3rd Walkthrough & Inspection Report of 1895 Jamesport Dr PSL, FL 7.13.06

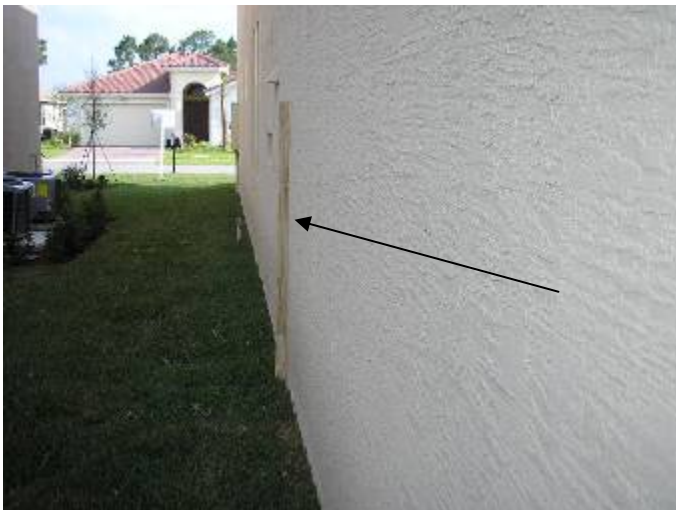
The opening in the cabinet is not big enough to allow the whirlpool tub pump motor to be accessed for service.

§P421.2 Installation. Whirlpool bathtubs shall be installed and tested in accordance with the manufacturer's installation instructions. The pump shall be located above the weir of the fixture trap. Access shall be provided to the pump.

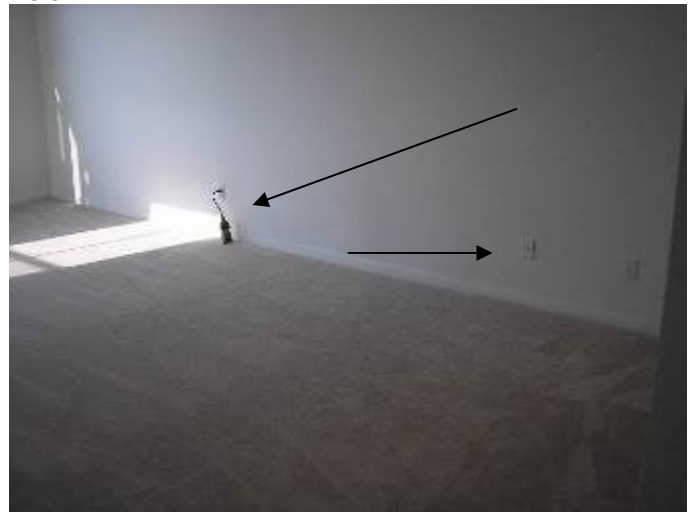
Note: Some of the receptacle outlets had voltage drops that exceed 5% 2002(NEC) 210.19 Conductors. - See Below.

See the builder's/electrical engineer's response to this item. **The voltage drops noted in the report are referenced as a suggested guideline & informational only. They are not considered a violation of the code & this condition is not enforceable.**
